Meeting of the Subdivision Authority Electronic Meeting Tuesday, October 5, 2021 at 3:00 p.m.

B. PL20210015

Gateway at Three Sisters Mountain Village Subdivision of Lots 3, 4, 5, Block 18, Plan 0812528 and Lot 1, Block 19, Plan 1510968 into 1 multi-family residential lot, 10 commercial lots, municipal and environmental reserve lots, public utility lots and roads 1.

PL20210015 Schedule A

Figure 1.

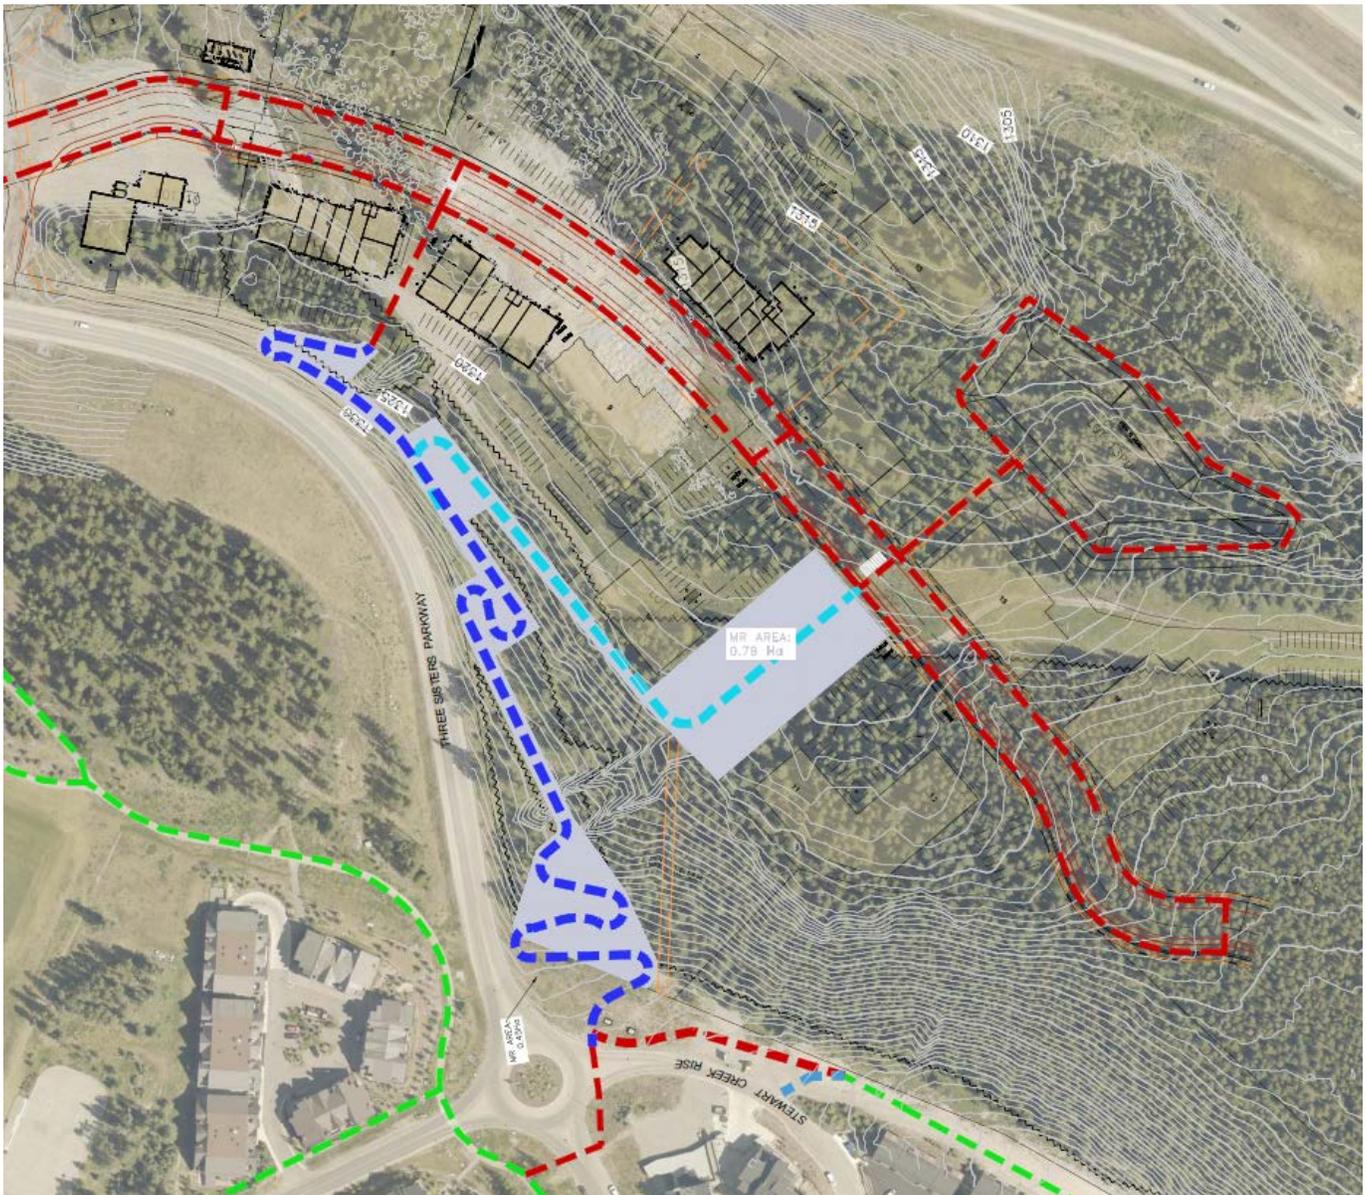
22. The developer shall design and construct, as conceptually shown in Figure 1:
- a 3.5 m asphalt pathway connecting from the existing pathways at the Stewart Creek roundabout along the general alignment of existing URW Plan 021 2809, to the principal commercial street.
 - a 3.5 m asphalt pathway connecting to the pathway in (a) above to a location further southeast along the principal commercial street, connecting to the stormwater pond trail.
 - A gravel trail around the stormwater pond.

If during the detailed design process the developer proposes an alternative alignment for the pathways in (a) and (b) which satisfies the Town's EDCG and the design criteria in condition #23, it may be considered for acceptance by the Town of Canmore.

Figure 2

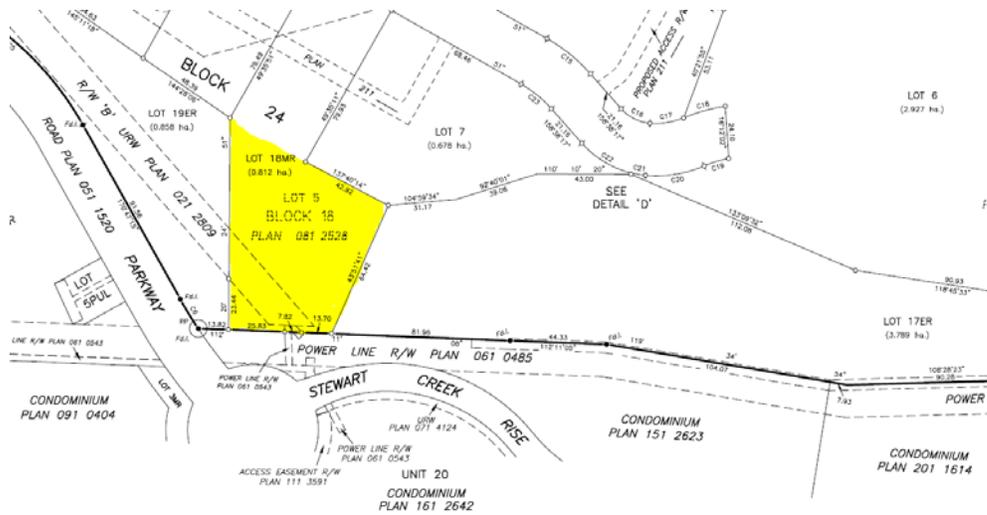
- ~~31-32.~~ The boundary of Lot ~~18MR-16MR~~ as shown on the submitted Tentative Plan of Subdivision shall be adjusted to adequately consider steep and unstable slope conditions. The approximate 0.5 hectare area of steep and unstable land as shown in Figure 2 shall be designated Environmental Reserve (ER).

TENTATIVE PLAN

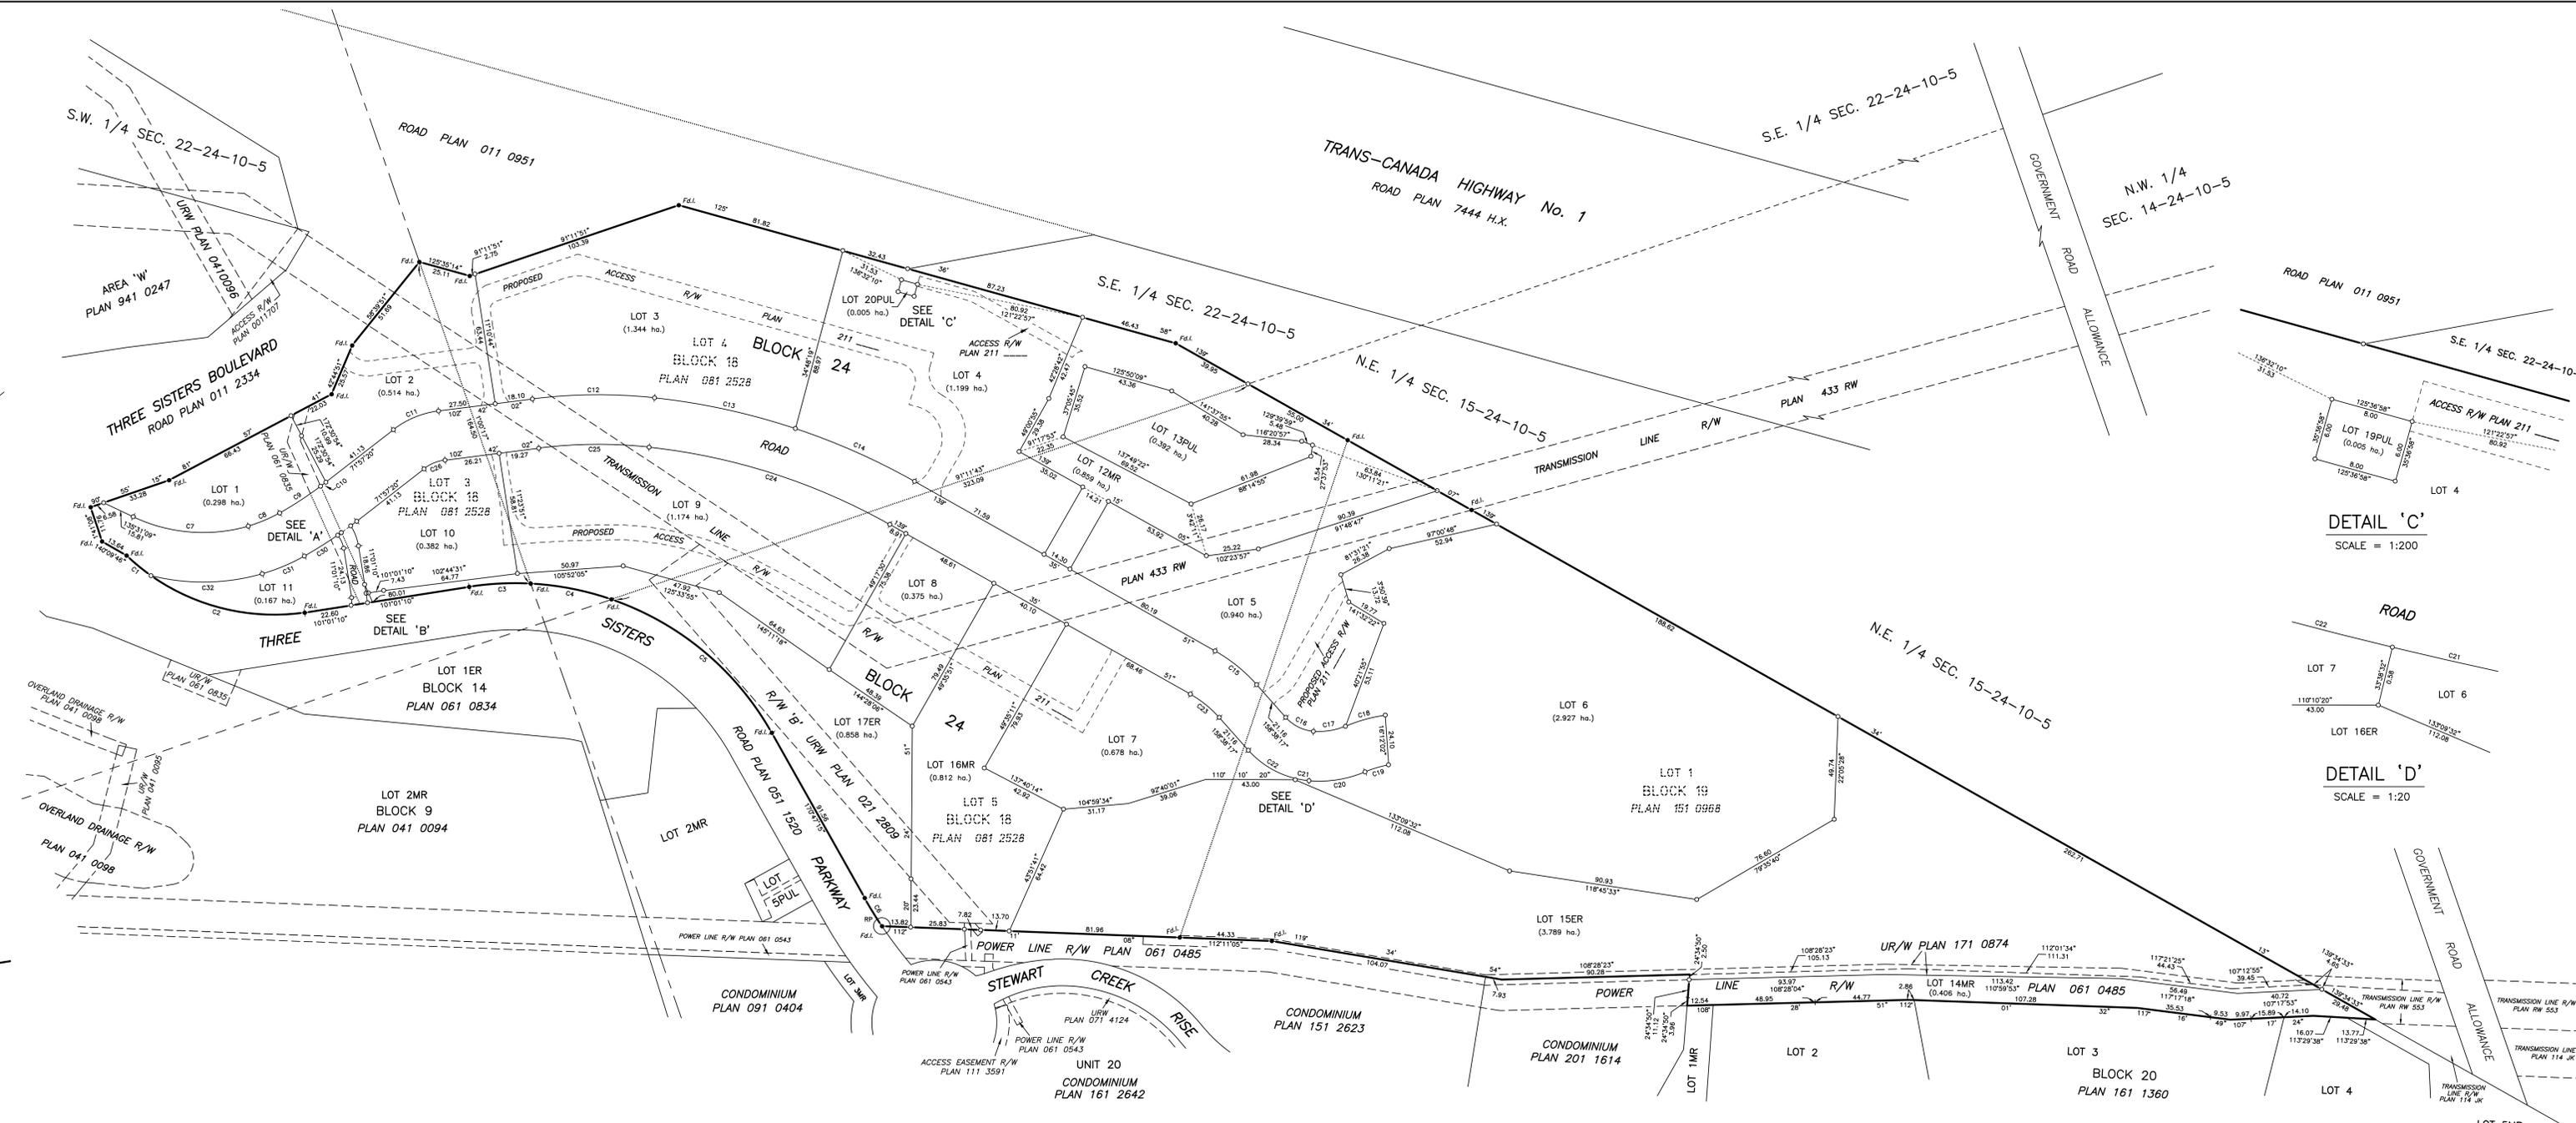
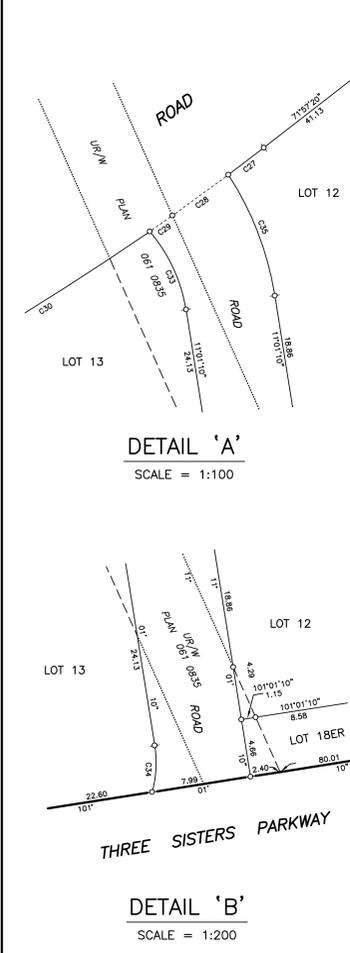
- b. The number of driveways onto the principal commercial street must be minimized to reduce conflict points with pedestrian and cyclists.
 - c. Proposed access must be shown for 'Lot ~~43~~¹¹' (as identified in the submitted Tentative Plan of Subdivision).

16. The developer shall design the water system with all new public water mains to be located on public lands, such as road or PUL. Specifically, the loop through ‘Lots 3 and 4’ (as identified in the Tentative Plan of Subdivision) must be removed and the design changed to private service line stubs.

~~38.39.~~ Prior to endorsement, the developer shall prepare an easement or other such agreement for the proposed snow storage area on Lot 7 for use by Lots 1 through ~~1311~~, Block 24 as identified on the drawings submitted in the application. The easement must be registered concurrent with the plan of subdivision.
